NAVY DEPARTMENT

Report of Test

Horn, Navy Type H-4

Federal Electric Company,

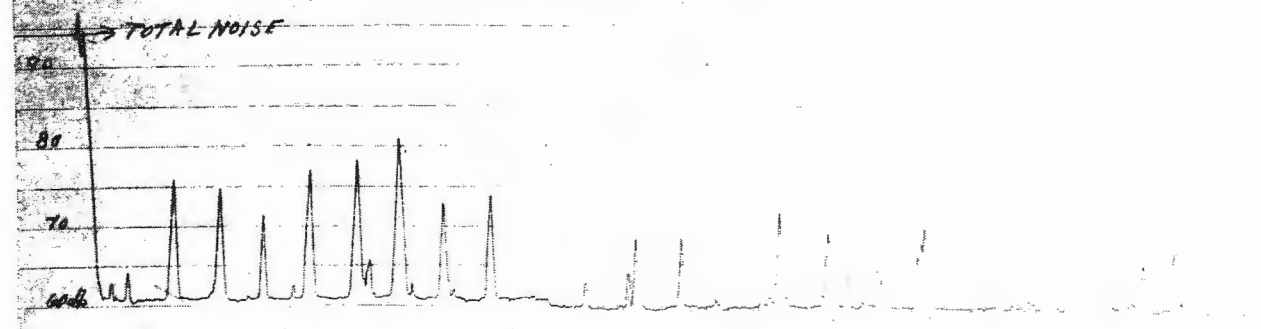
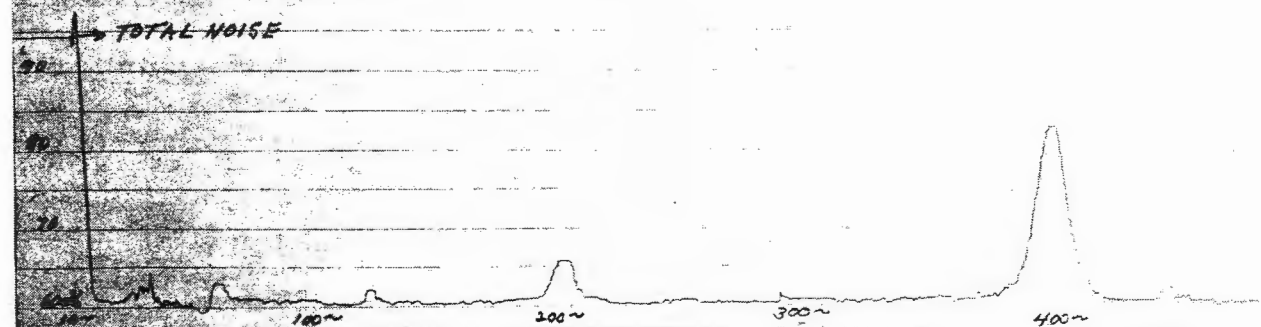
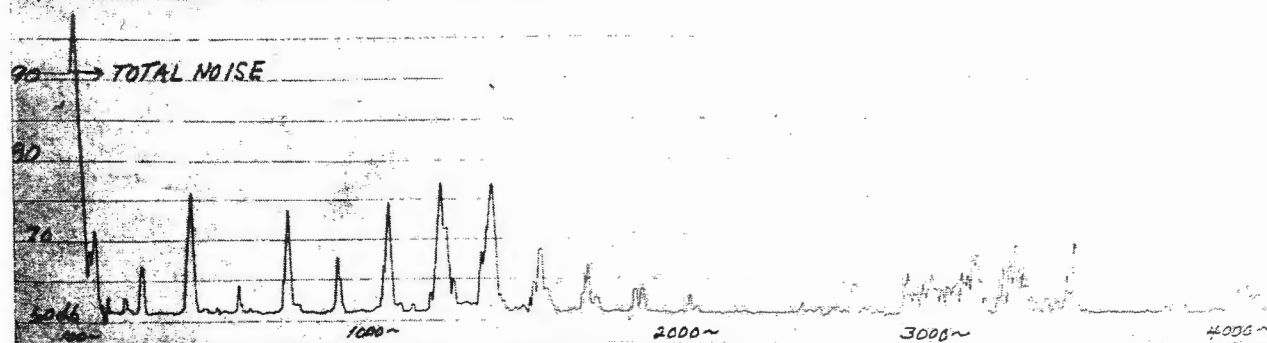
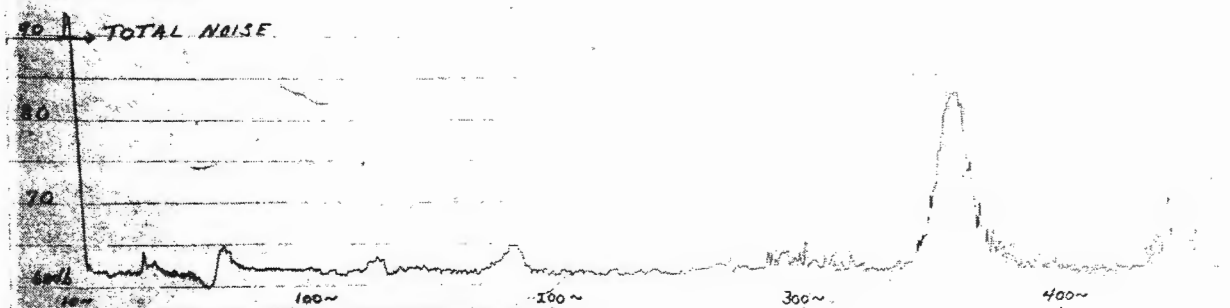
II. The subject horn, manufactured by Federal Electric Company, Chicago, Illinois, as Navy type H-4, complied with the specifications, reference (b), except in the following respects:

- (1) Steel inserts are not provided in housing cover (pc. 2) for machine screws (pc. 69) securing the chassis to the cover.
- (2) One screw (pc. 7) is not accessible, due to its location under projector (pc. 3). Drawing, reference (c), shows two screws so located but, as submitted, the position of projector was as shown by Plate 2.
- (3) Contact spring (pc. 43) is of blued steel.
- (4) Brass spacers (pc. 57) under the terminal block are in contact with aluminum.
- (5) Terminal tube bosses are not correctly located. The specifications require that one be located at the top and one at the bottom.
